366 Jamison Road,
Jamisontown NSW
2750

**Response To Submissions for SSD-
68603709**

On behalf of SummitCare Penrith

11 February 2026

Figure 2: Proposed Building A Section 84 Building Envelope Compliance (Jackson Teece)

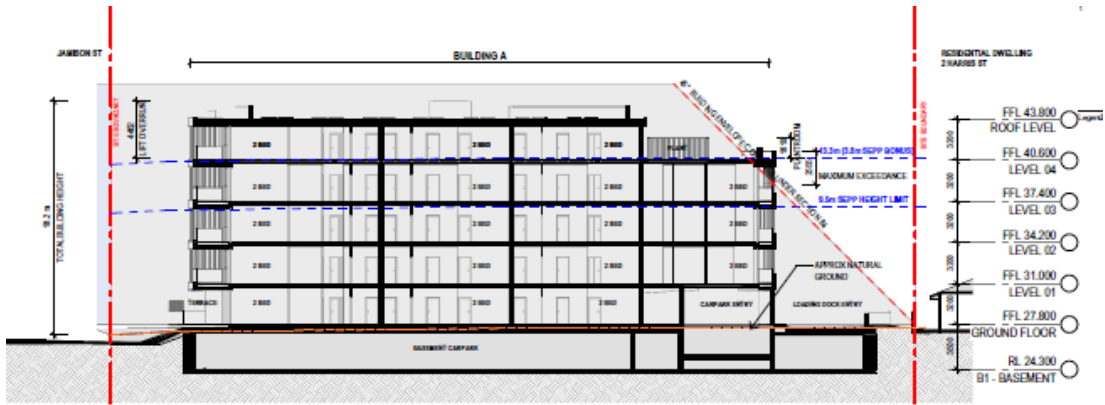
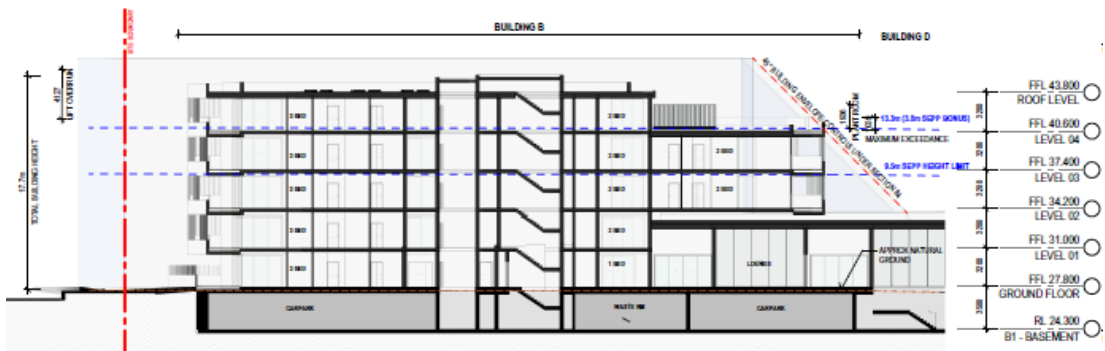
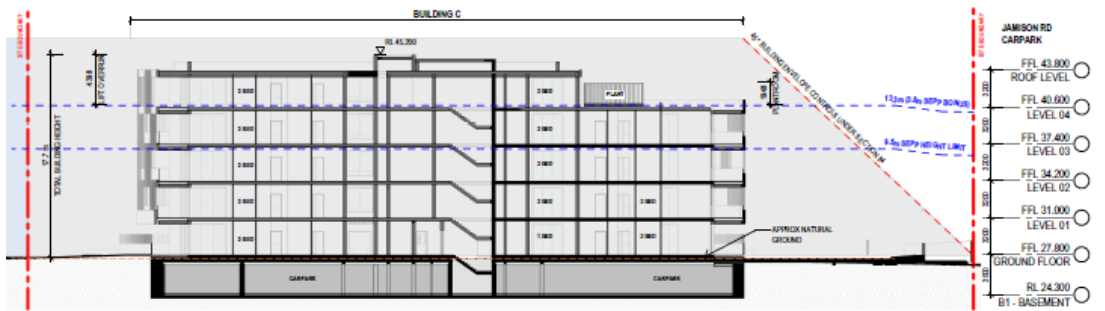
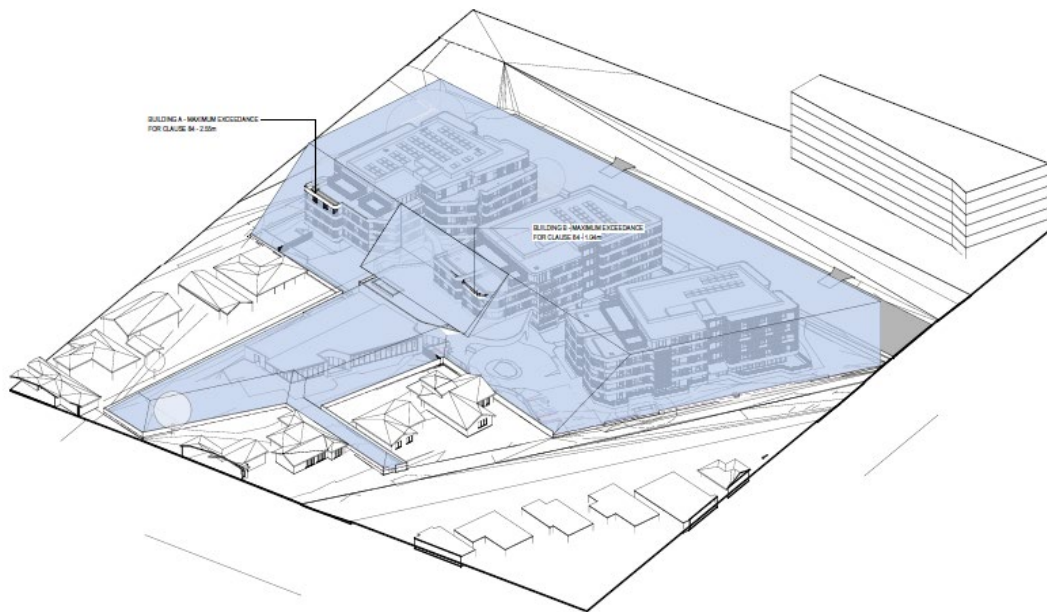
<p><u>Section 84 Housing SEPP Compliance</u></p> <p>Provide elevation plans demonstrating compliance with section 84(2)(c)(iii) of the <i>State Environmental Planning Policy (Housing) 2021</i> (Housing SEPP), showing that the third to fifth storey are set back within planes projecting at a 45-degree angle inward from the side and rear boundaries of the site.</p>	<p>Jackson Teece has prepared elevational plans and building envelope diagrams addressing the building envelope controls within Section 84(2)(c)(iii). Buildings A, B and C sit largely within the prescribed building envelope plane, with the exception of a minor non-compliance at the building parapet on Level 4 roofed area to the rear of Building A (with a maximum breach of 2.55m) and Building B (with a maximum breach of 1.03m).</p> <p>The Statutory Compliance Table have been updated to address Section 84(2)(c)(iii) of the Housing SEPP. In addition, the Clause 4.6 has been updated to address this minor breach.</p> <p>This is addressed in Section 5.5 of this report and refer to Appendix 1: Architectural Drawings, Appendix 7: Clause 4.6 Variation Request and</p>

Jackson Teece has prepared elevational plans and building envelope diagrams addressing the building envelope controls within Section 84(2)(c)(iii). Buildings A, B and C sit largely within the prescribed building envelope plane, with the exception of a minor non-compliance at the building parapet on the Level 4 roofed area to the rear of Building A and Building B.

Jackson Teece have prepared elevational plans and building envelope diagrams addressing the building envelope controls within Section 84(2)(c)(iii). Buildings A, B and C sit entirely within the prescribed building envelope plane, with the exception of a minor non-compliance at the building parapet on the Level 4 roofed areas to the rear of Building A (with a maximum breach of 2.55m) and Building B (with a maximum breach of 1.03m). Updated shadow diagrams have been provided demonstrating the impact of the breach to be negligible. Refer to **Appendix 1: Architectural Drawings**. The Statutory Compliance Table has also been updated to address Clause 84(2)(c)(iii) of the Housing SEPP. Refer to **Appendix 14: Statutory Compliance Table**. The Figures below shows the minor breach:

The Clause 4.6 variation, prepared by The Planning Studio has been updated to address the minor breach of the development with the building envelope controls. The Clause 4.6 confirms that compliance with the maximum Building Envelope development standard contained in Clause 84 of the Housing SEPP is unreasonable and unnecessary in the circumstances of the case, and that there are sufficient environmental planning grounds to justify the contravention to the development standard.
